Permit Reviews

Village of Pincrest

CASA ROBLES 131
6545 SW 131 STREET PINECREST, FLORIDA 33196

PROJECT DESCRIPTION:
SINGLE FAMILY RESIDENCE

WATER & GAS FLOOR PLAN

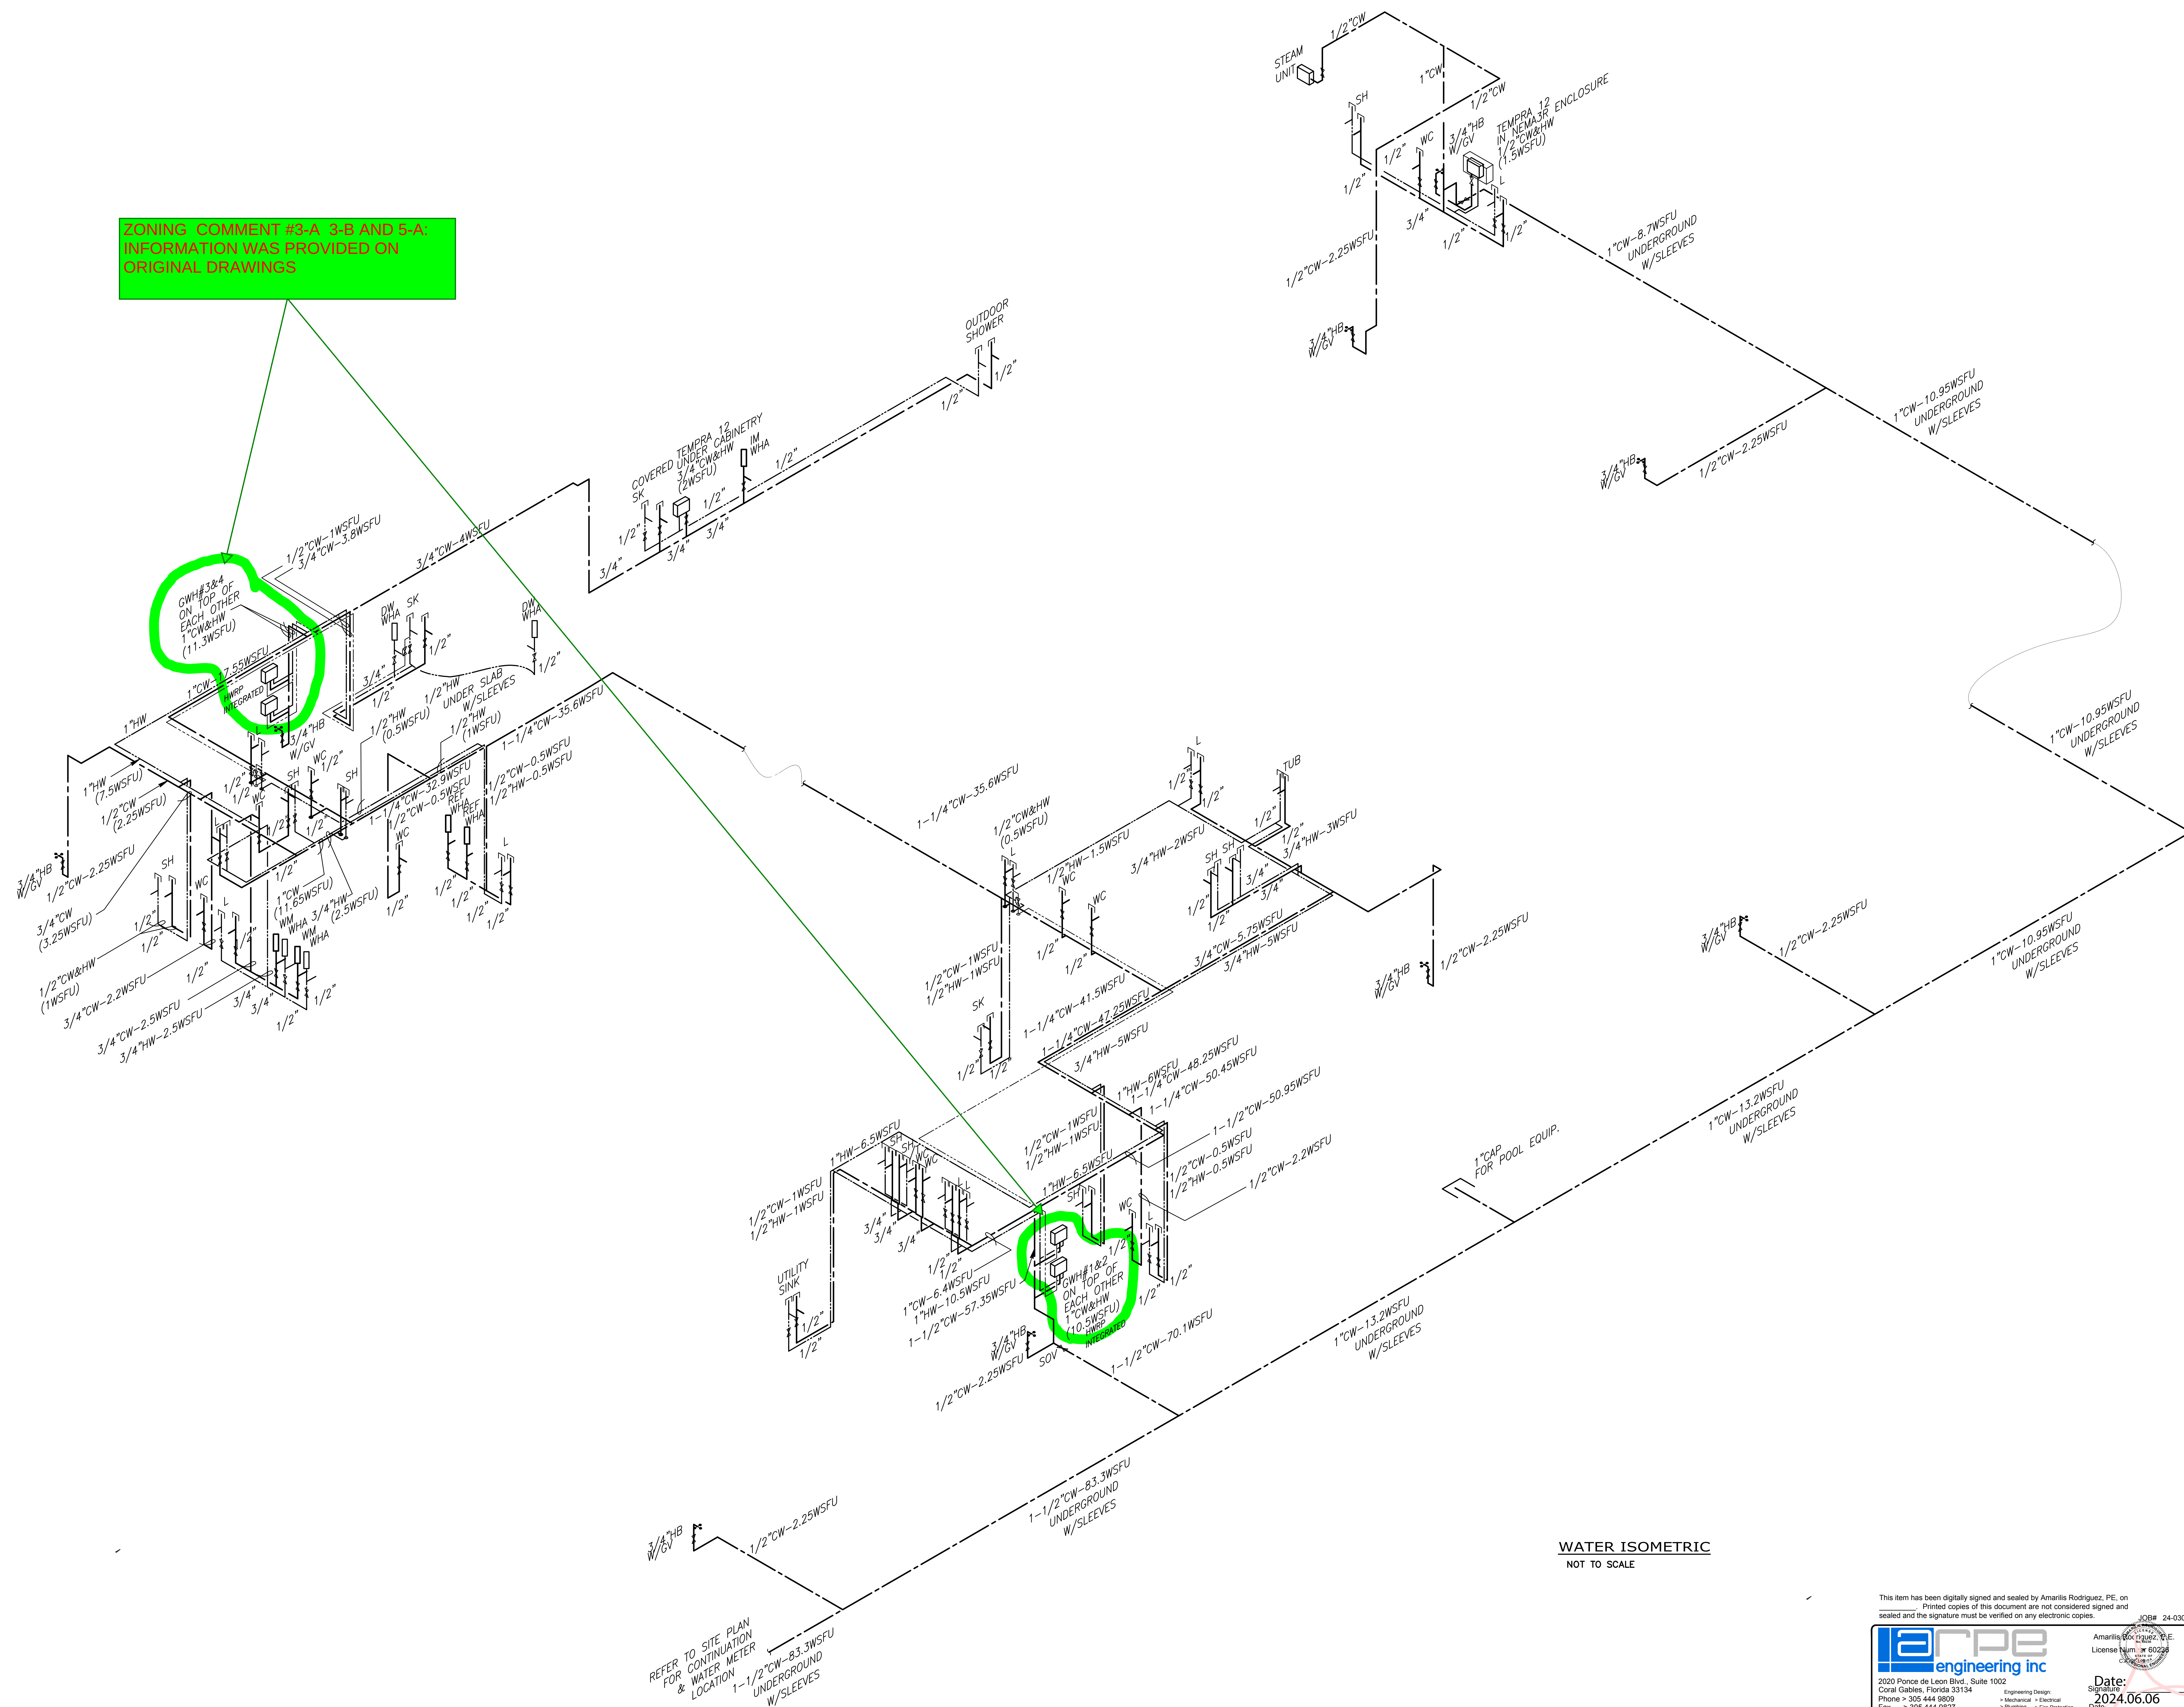
a) Photovoltaic Systems. Installation of an appropriate sized conduit, a minimum of one-inch diameter, leading from an exterior south-facing, east-facing, or west-facing roof, where a minimum of four hours of direct sunlight is achieved, to a stubbed junction box adjacent to the electrical meter. All exposed conduit shall be capped and provided with adequate flashing. The conduit shall not be located on or in the direction of a north facing roof. Roof reinforcements shall be addressed at the time of installation. COMMENT 3-A: INFO PROVIDED ON P-101.1, P-104.1, P-104.2, P-105, E-202, A-103

b) Solar Heating System. Installation of three-fourths inch diameter hot and cold copper water pipes from a south-facing, east-facing, or west-facing roof, where a minimum of four hours of direct sunlight is achieved, to an existing water heater tank. Both ends of the three-fourths inch diameter copper pipes shall be stubbed out and shall not be located on or in the direction of a north-facing roof. All exposed pipes shall be capped and provided with adequate flashing. Roof reinforcements shall be addressed at the time of installation. COMMENT 3-B: INFO PROVIDED ON P-101.1, P-104.1, P-104.2, P-105, E-202, A-103

COMMENT 5-A : INFO PROVIDED ON P-101.1, P-104.1, P-104.2, P-105

ZONING COMMENT #3-A AND 3-B:
INFORMATION WAS PROVIDED ON
ORIGINAL DRAWINGSZONING COMMENT #5-A:
INFORMATION WAS PROVIDED ON
ORIGINAL DRAWINGSSOLAR
GWHREFER TO SITE PLAN
FOR CONTINUATIONREFER TO SITE PLAN
FOR CONTINUATIONZONING COMMENT #3-A AND 3-B:
INFORMATION WAS PROVIDED ON
ORIGINAL DRAWINGSZONING COMMENT #5-A:
INFORMATION WAS PROVIDED ON
ORIGINAL DRAWINGS

1
E-101
POWER FIRST FLOOR PLAN
SCALE: 3/16"=1'-0"

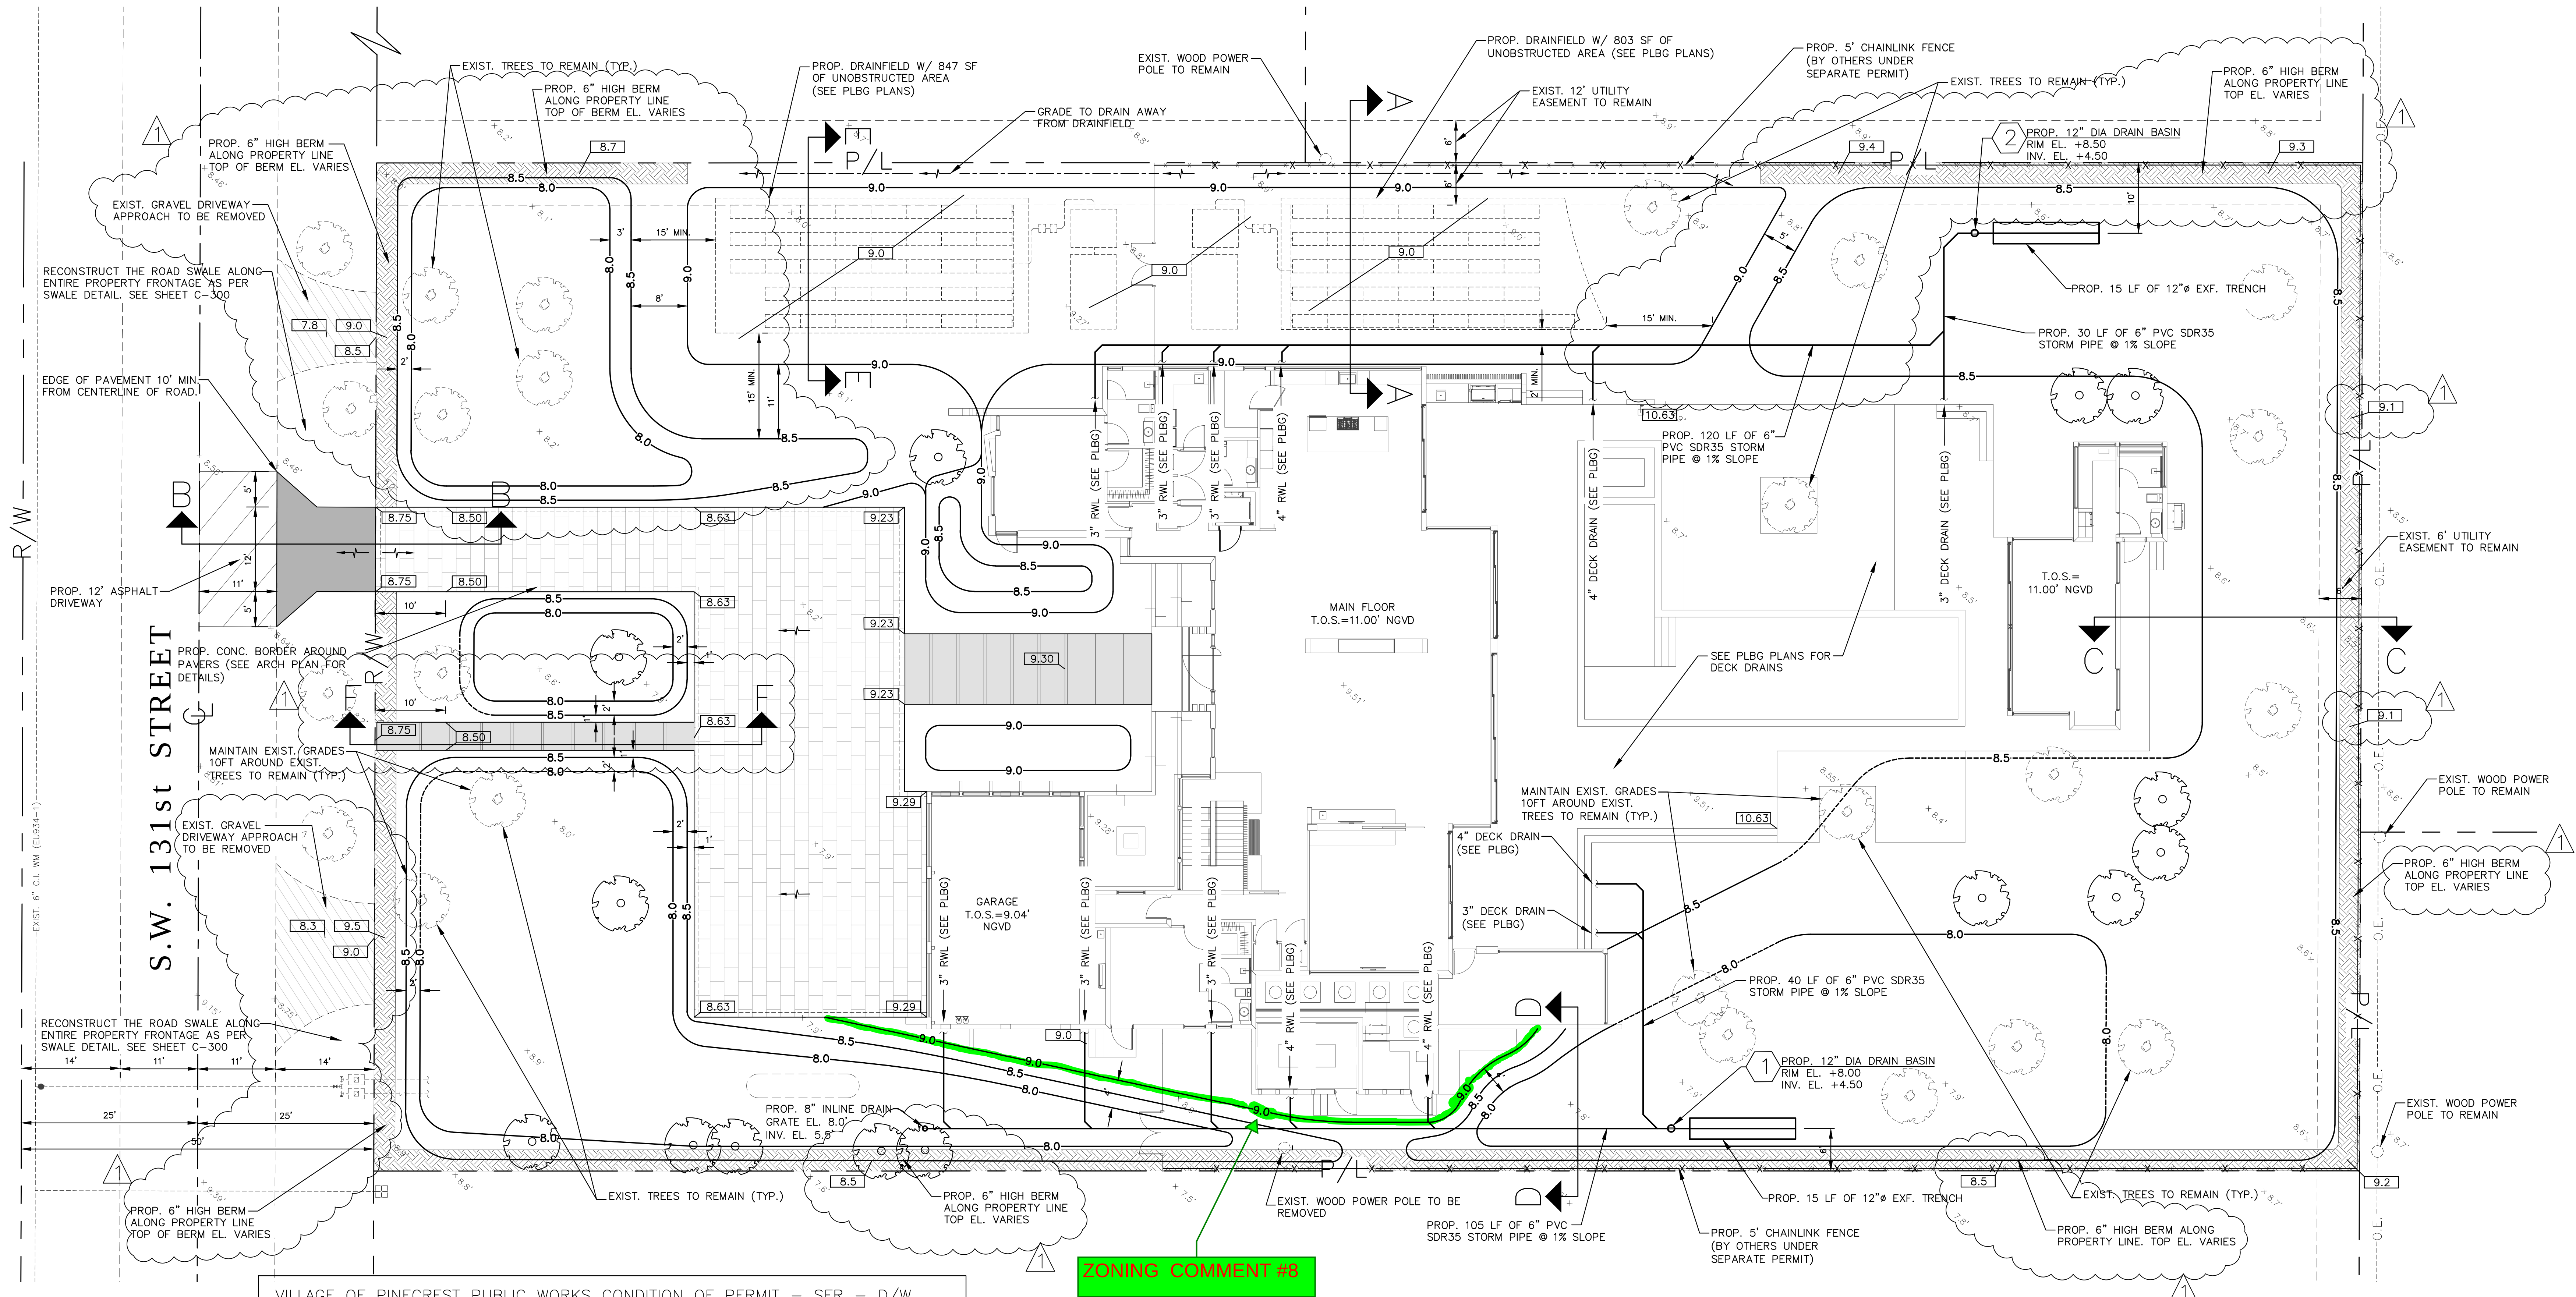
Please Note: The Site Plan and the Electrical Plan show a future generator. Please note that a generator requires a separate permit and the exact location to be determined based on the manufacturer's sound data specification. The generator must be installed prior to TCO or CO to meet this requirement

1" CONDUIT WITH PULL STRING FROM A JUNCTION BOX ADJACENT TO ELECTRICAL METER TO ROOF FOR FUTURE PHOTOVOLTAIC SYSTEM TO BE INSTALLED FACING WEST WITH A MINIMUM OF FOUR HOURS OF DIRECT SUNLIGHT. THE CONDUIT SHALL NOT BE LOCATED ON OR IN THE DIRECTION OF A NORTH FACING ROOF.

ZONING COMMENT #4 (GENERATOR):
INFORMATION WAS PROVIDED ON
ORIGINAL DRAWINGS

ZONING COMMENT #8

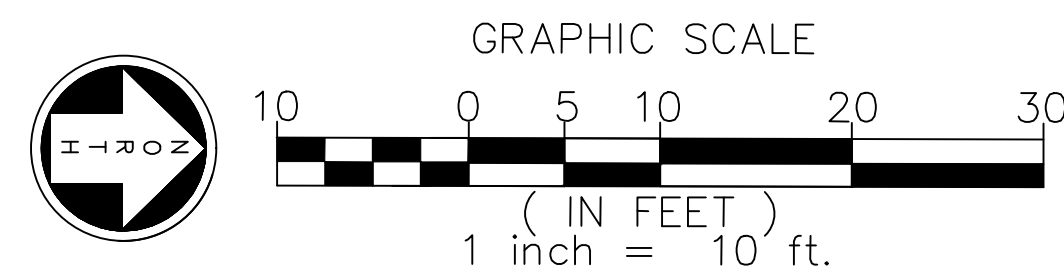
8. Please note that the maximum height of a free-standing wall is six feet from the side with lower grade

COMMENTS: GRADE AROUND WALL EQUIPMENT ENCLOSURE ON THE EAST SIDE OF HOUSE IS 9 NGVD AND WALL HEIGHT IS 15 NGVD THEREFORE WALL HEIGHT IS SET TO 6' IN HEIGHT. PLEASE REFER TO CIVIL C-100 DRAWING FOR GRADE ELEVATIONS AROUND WALL AREA
